DETAIL of NEW WALLS

Detail of Structural Beam

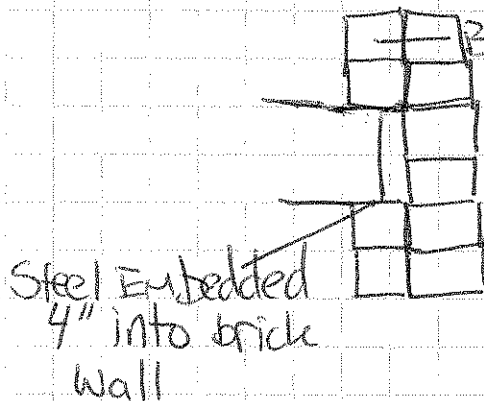
~~Fact~~
A double W8x10 steel beam to span 9' wide clear opening between dining Room and Kitchen.
Beam to be inserted 4" into existing brick walls for support.

To be field verified post-demolition

Rebrick and grout solid around beam bearing locations.
